Dave

9/4/02

Ver 17

comments

Figure 5-1 Cross Section Isovelocities at Mile 34.3, Dogtooth Bend Prototype, Mississippi River (Davinroy, 1994)

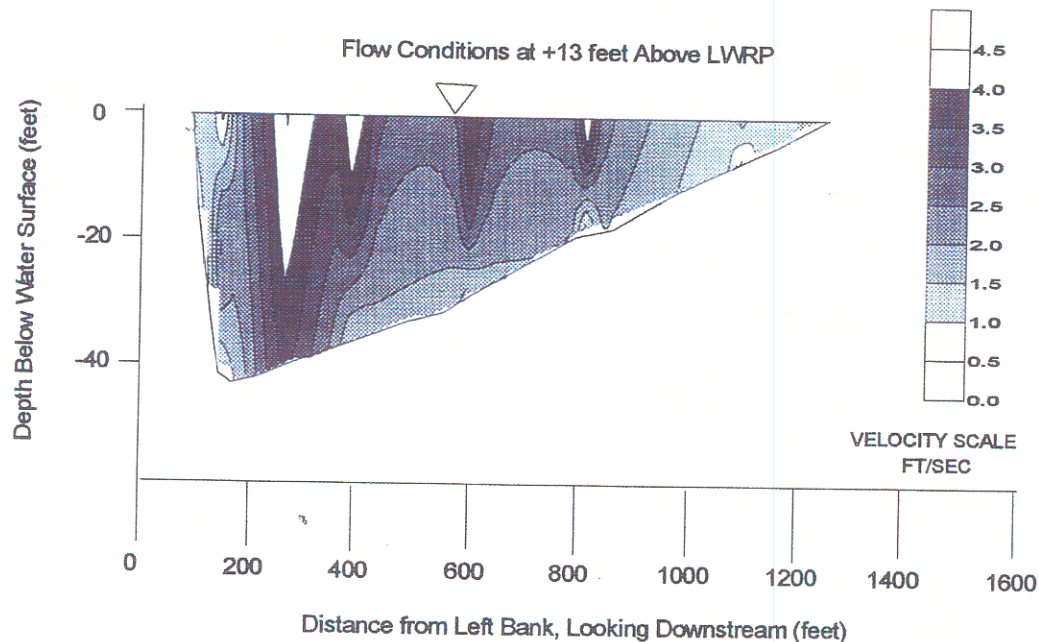
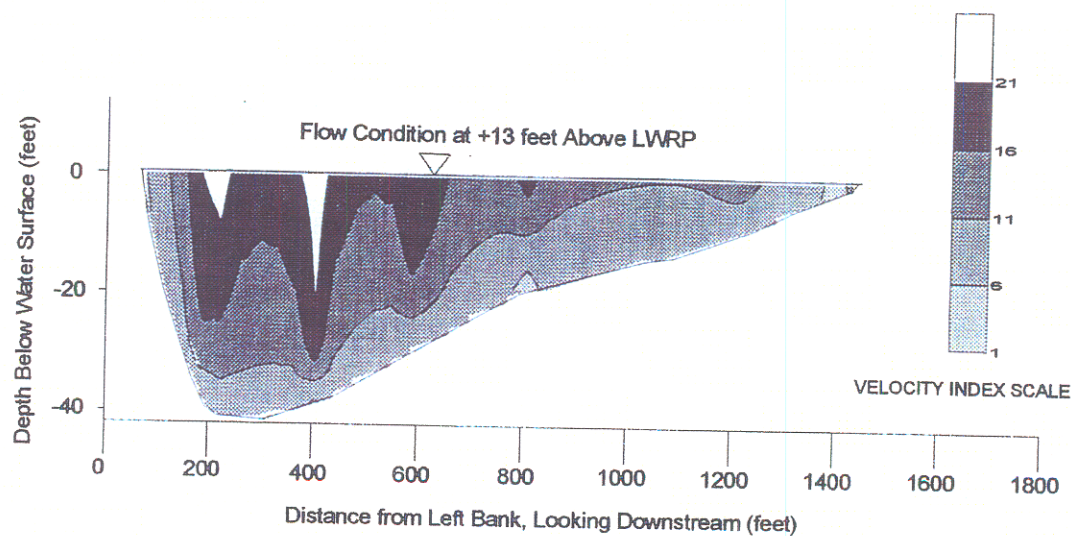
6. Surface velocity patterns are adversely affected by scale distortions and exaggeration of Froude Number. We have data from a large model with extremely low distortion that did not reproduce the correct velocity distribution because the correct bed was not reproduced, channel thalweg location, etc. This cannot be ignored... Increased distortion of the vertical scale results in model channels having smaller B/y than found in the prototype channel. Circulation in channels with small B/y ratios is stronger as evidenced by observations in the laboratory and in small streams. Davinroy (1994) presents corroborating isovelocity data for prototype and model at a cross-section in the Dogtooth Bend reach of the Mississippi River (Figures 5-1 and 5-2, respectively). (you have got to be kidding me? What are you trying to do here Andy? Do you think that this one cross section is going to support your conclusions?? How accurate do you think the anometer was? You are contradicting the use of flow visualization....Visualization was used to show general trends in this case, it was not used to make exact measurement comparisons....we have stressed this point many times and you have agreed how it

should be used...yet now you are using visualization out of the blue to quantify? To try and support a case???? Why? Don't understand this..... Davinroy's figures depicting isovelocity contours indicate a somewhat stronger circulation pattern in the micromodel than found in the prototype. Although there are similarities between the prototype and the model in that both exhibit several higher velocity cells across the channel width, the lateral distribution is different in the micromodel than shown in the prototype (Figures 5-1 and 5-2). The prototype data show the highest thread of velocity located approximately 250 feet from the left bank position while the micromodel data show the highest thread of velocity at a distance of 400 feet, a difference of 150 feet. The difference of 150 feet between these locations may appear minor. However, this represents approximately 10 percent of the total channel width (unbelievable that you are using the visualization in this manner....you are contradicting your own reservations about the use of flow visualizations and are trying to use it way beyond what it is meant to be.
